**TOWN OF NEWBURGH
PLANNING BOARD
TECHNICAL REVIEW COMMENTS**

PROJECT NAME: MKJ PARK, LLC OFFICE & WAREHOUSE
PROJECT NO.: 22-32
PROJECT LOCATION: SECTION 34, BLOCK 2, LOT 29.1
REVIEW DATE: 13 SEPTEMBER 2024
MEETING DATE: 19 SEPTEMBER 2024
PROJECT REPRESENTATIVE: LANC & TULLY, PC /JOHN QUEENAN, P.E.

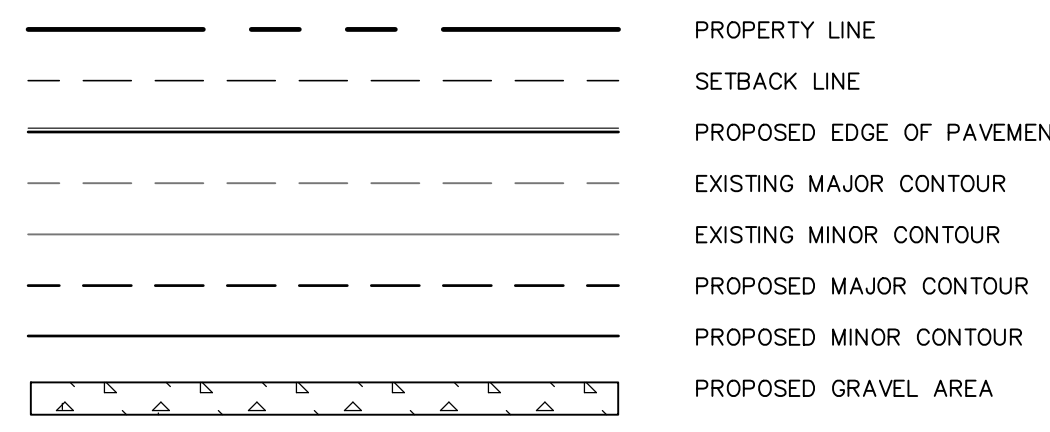
4. A Stormwater Prevention Pollution Plan will be required.
5. The basis of design for the subsurface sanitary sewer disposal system 83 employees should be documented. It is noted that the design of the subsurface sanitary sewer disposal system is 996 gallons per day based on that employee count and water saving fixtures. Flows greater than 1,000 gallons require NYSDEC SDDS Permit and Orange County Health Department approval.

10. Parking count identifies identifies 166 employees for the warehouse and 35 employees for the office. Calculations should be addressed when evaluating the subsurface sanitary sewer disposal system.

WETLAND MITIGATION PLAN AND DETAILS
PREPARED FOR

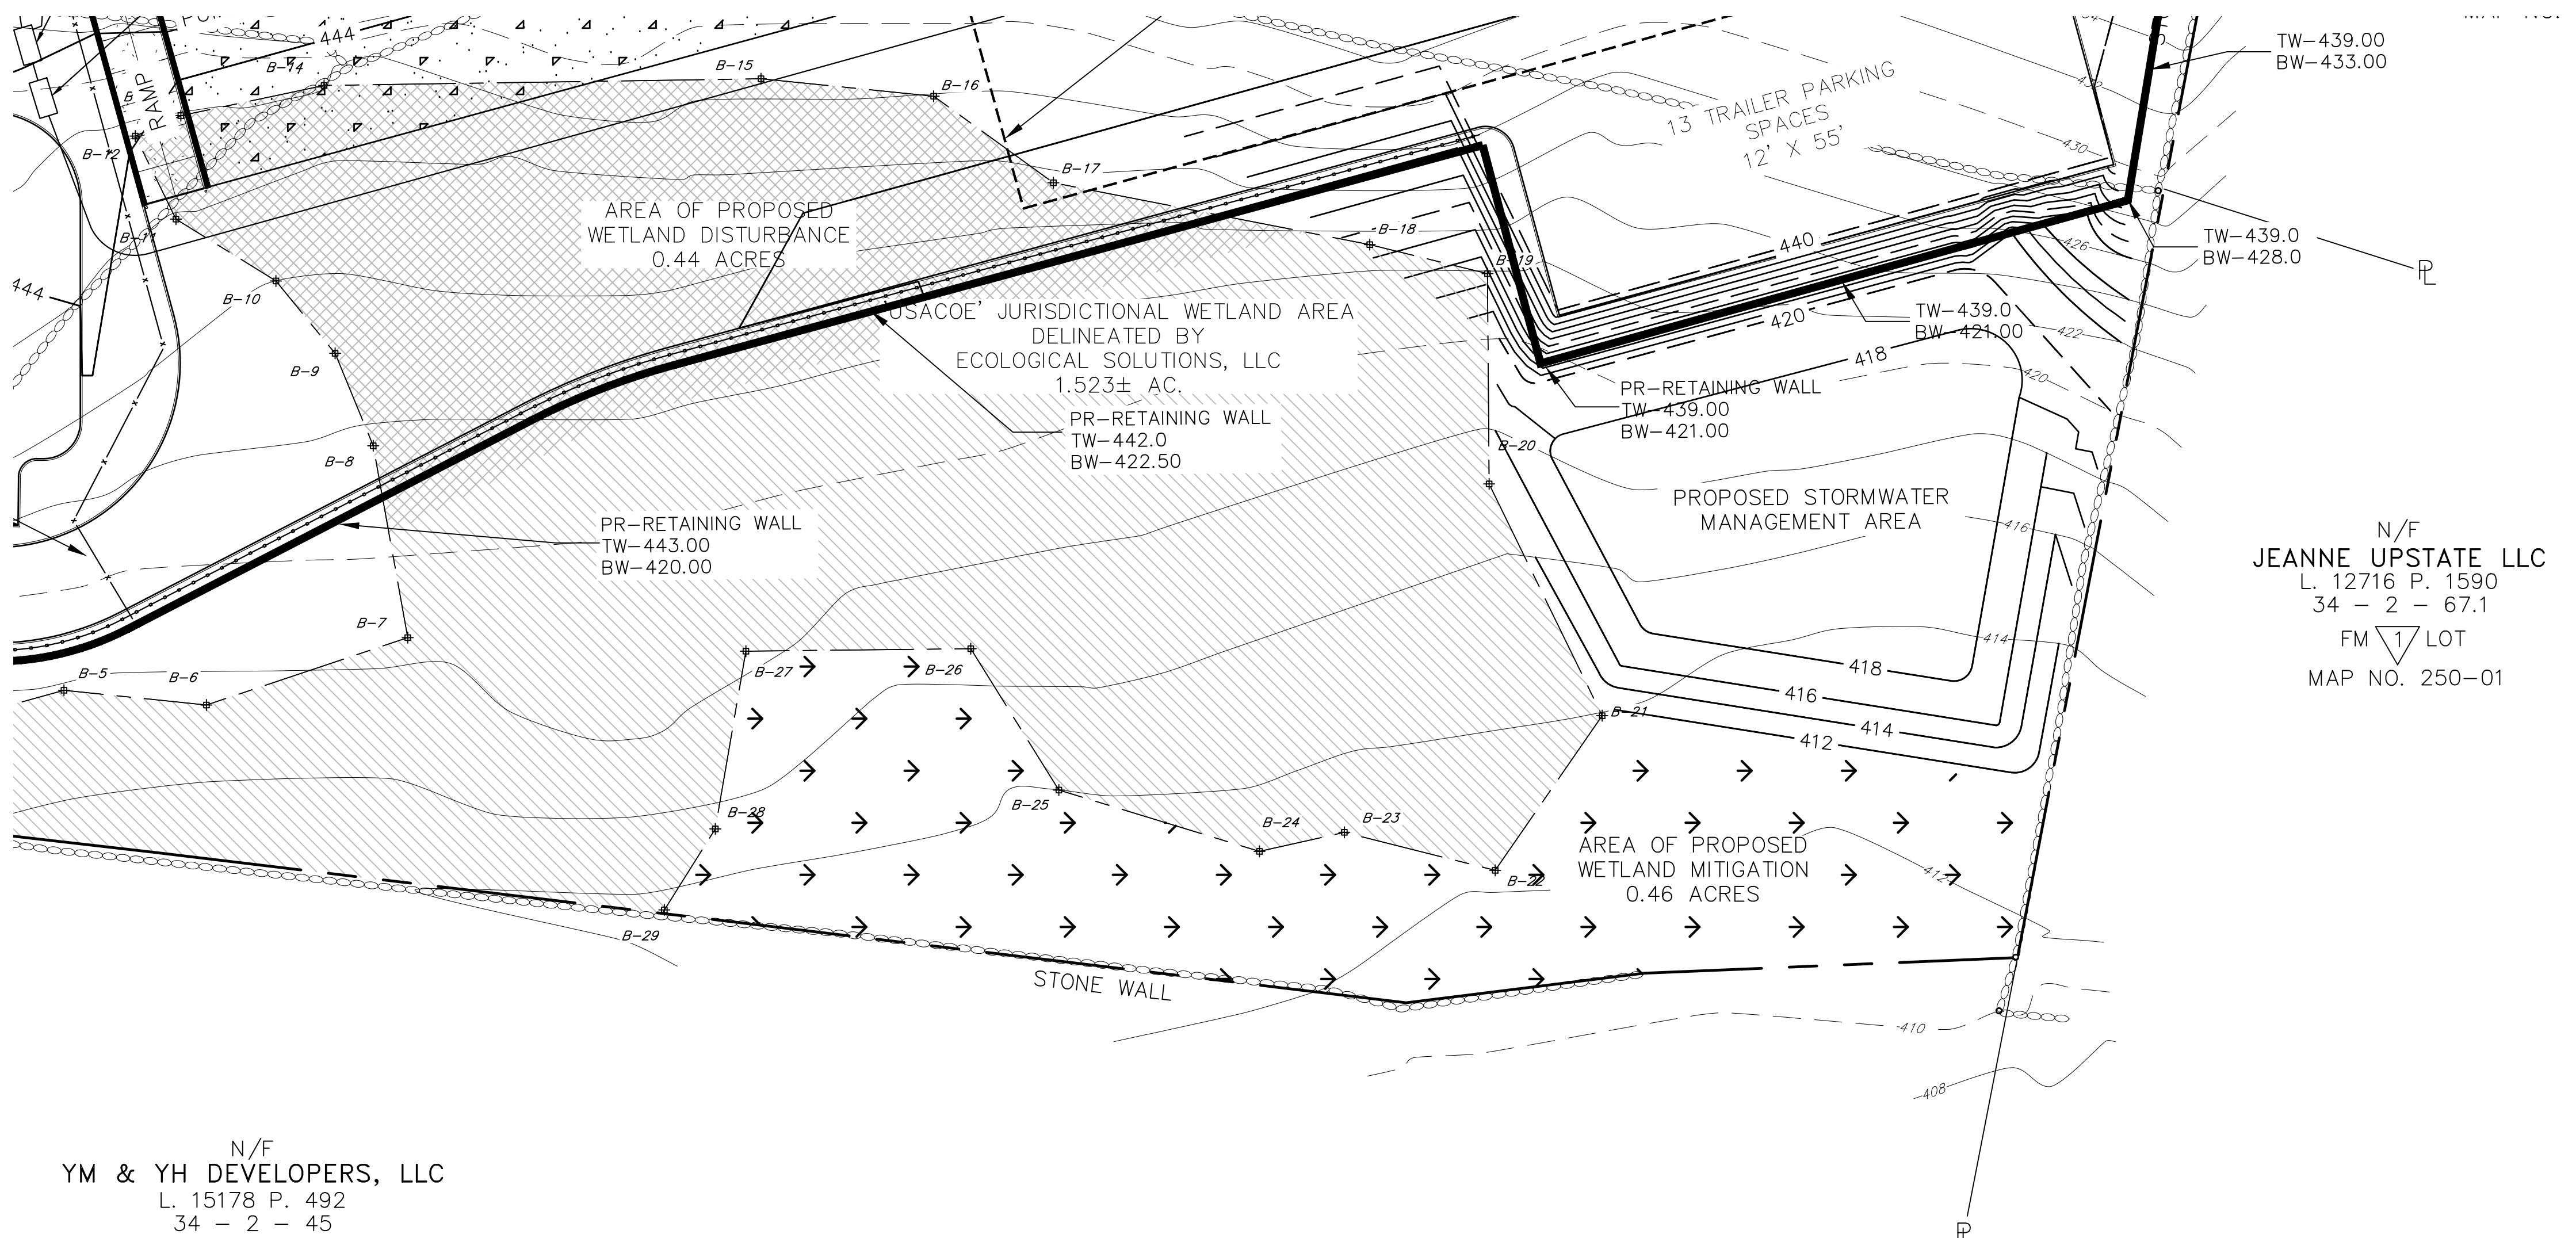
6. The project is disturbing US Army Corps. of Engineers jurisdictional wetlands. Army Corps. approval and NYSDEC Permit is required.
7. Orange County Planning Department referral will be required for future submissions.
